~~GWS Septic System Design Review~~ 7099B

GWS File #: 7099B Approved ☐ Disapproved ☒

SUBJECT: Septic system design on Lot 24 in Granite Ridge Subdivision, Brief Road, Mecklenburg Co., NC.

By THOMASON, TREVOR: 6/26/08 2:58:53 PM
Design review disapproved for the following:

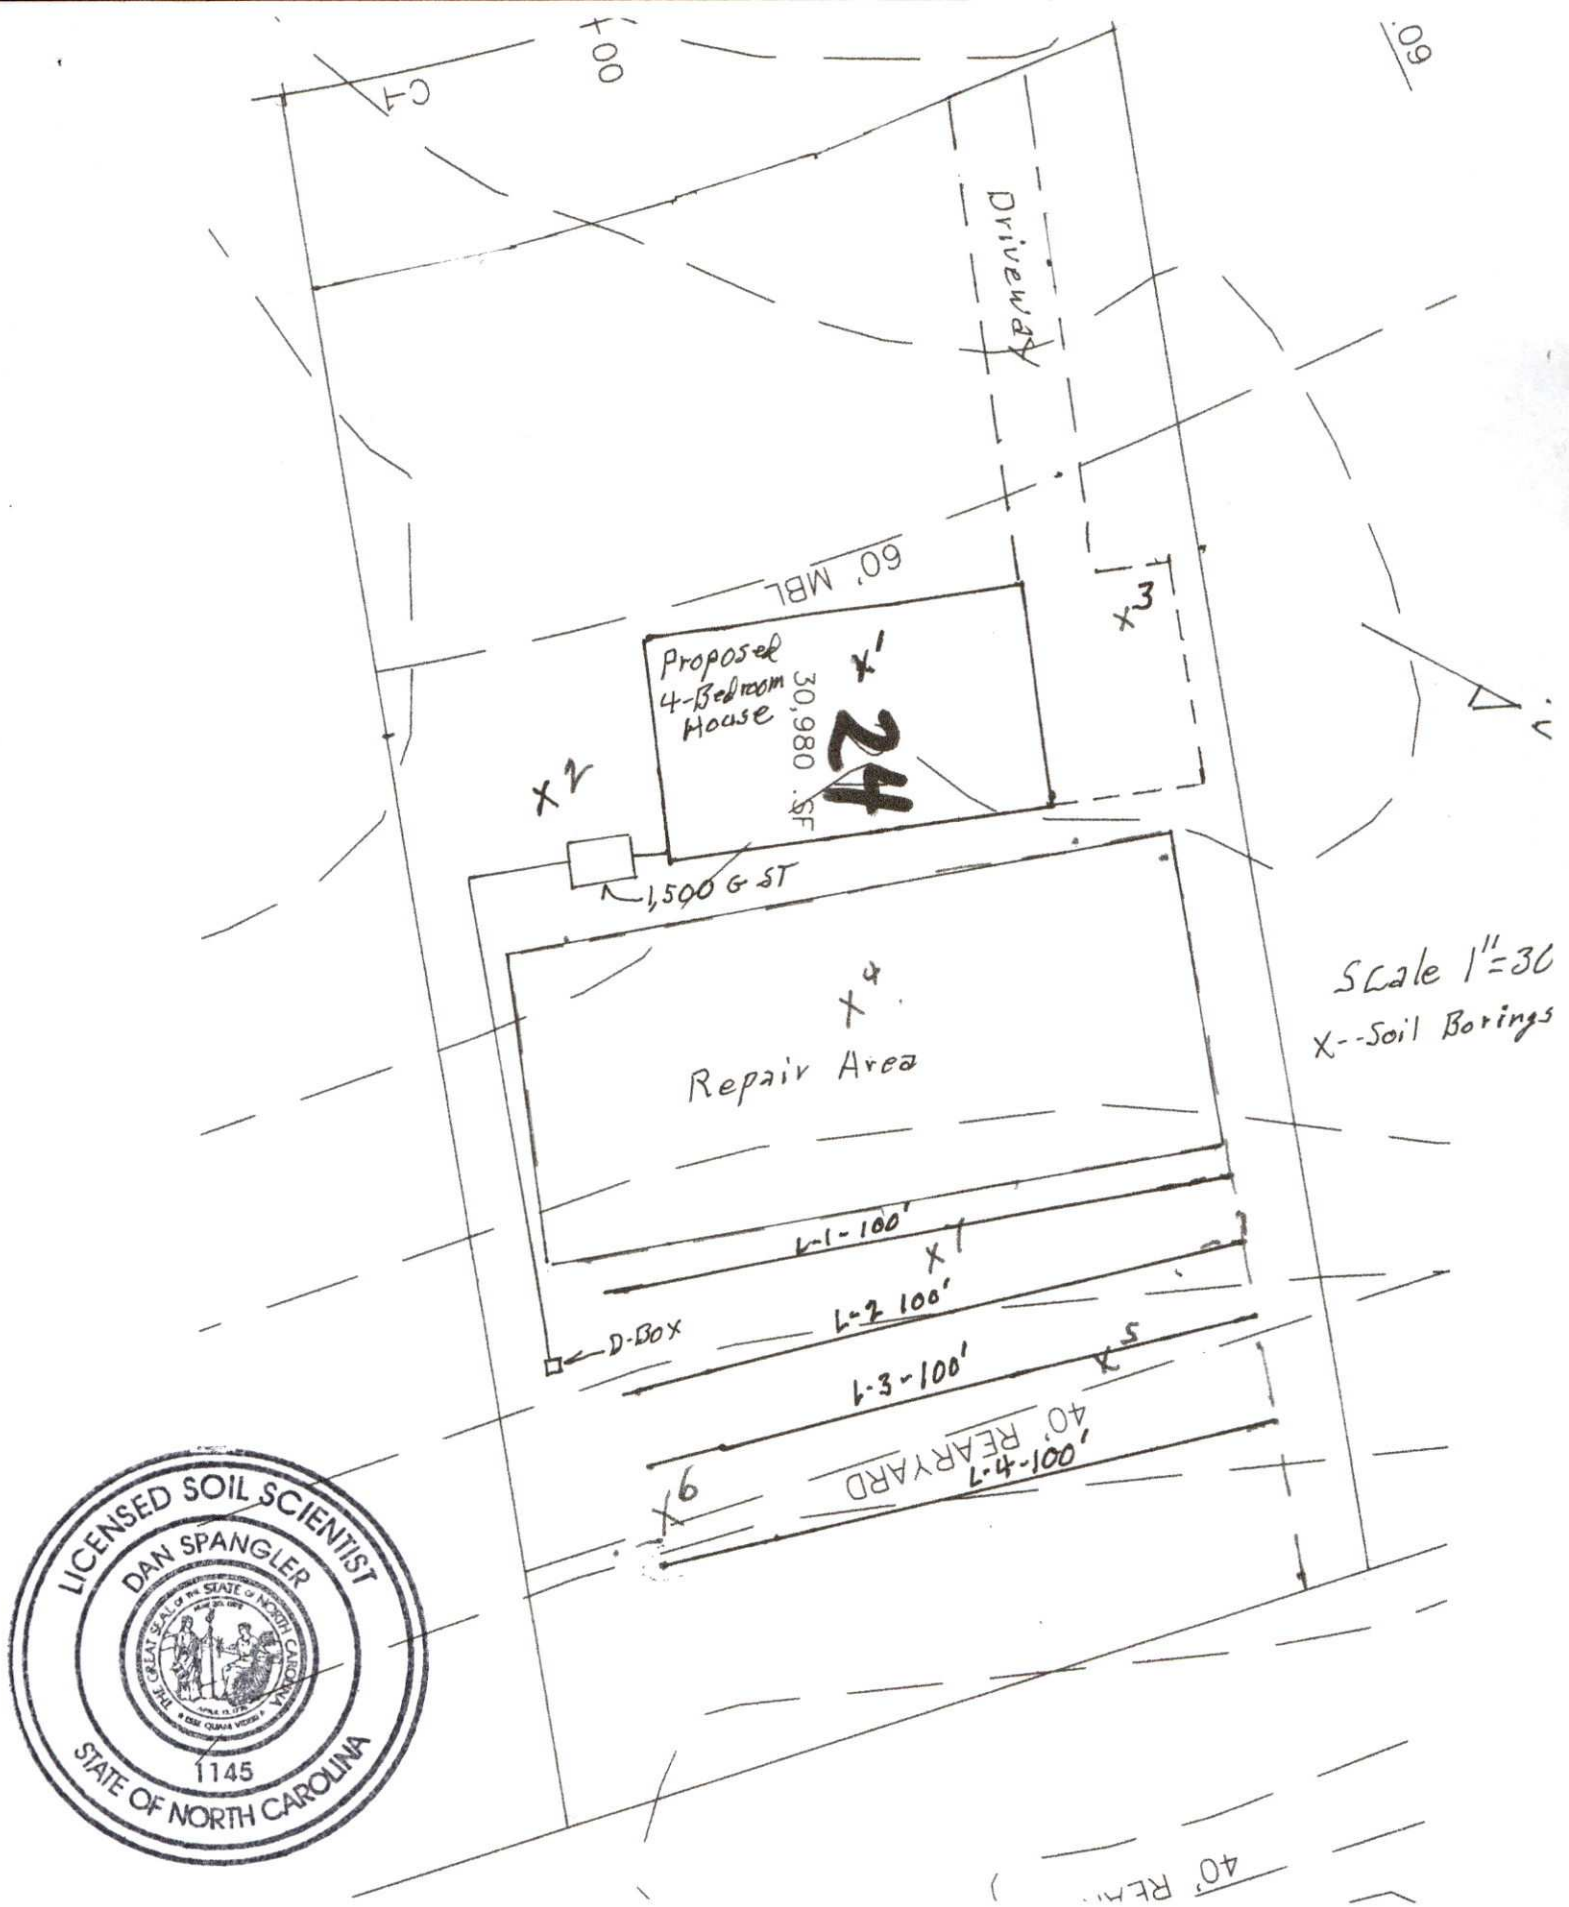
5 BEDROOM APPLICATION ON FILE.

* MCHD SOIL REPORT INDICATES SITE LTAR = 0.2.

5 bedroom application on file. Plan indicates system design for 4 bedrooms.

MCHD soil report indicates site LTAR = 0.2 not 0.3 listed on plan.

Revised plan required in order to continue processing application.
